NEW MEXICO OIL CONSERVATION DIVISION Engineering Bureau – UIC Program

WLC South Federal SWD Well No.1

C-108 - LOCATION AMENDMENT

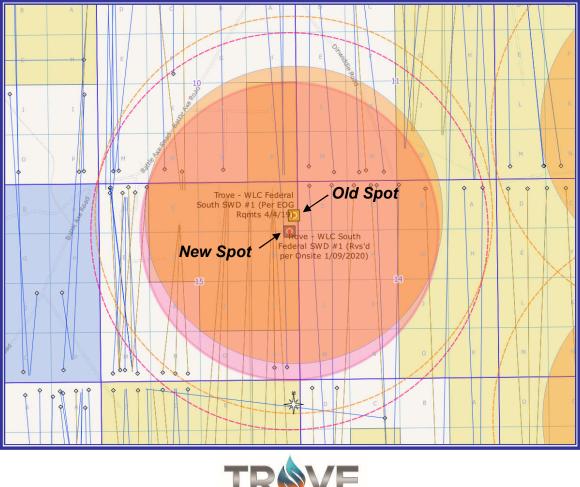
On January 9, 2020 Trove Energy and Water accompanied BLM personnel from the Carlsbad Field Office to conduct an onsite inspection pursuant to Notice of Staking (NOS) requirements. On the ground, it was discovered that;

there is an unmovable allotment fence running N/S along the east section line of section 15. BLM requires that a pad area be a minimum of 30 feet off this fence.
a well pad extension had been staked by Mewboune Oil Company to the east of the existing pad.

These two factors forced the move of Trove's proposed SWD well spot to the south and west to accommodate both interests. A site was selected based on onsite conversations with BLM personnel.

Therefore, Trove proposes moving the location <u>from</u> 900' FNL x 100' FEL <u>to</u> **1340' FNL x 220' FEL**. *This is move does not change the AOR significantly nor does it affect any additional persons, parties or interests.* New survey stakes were placed.
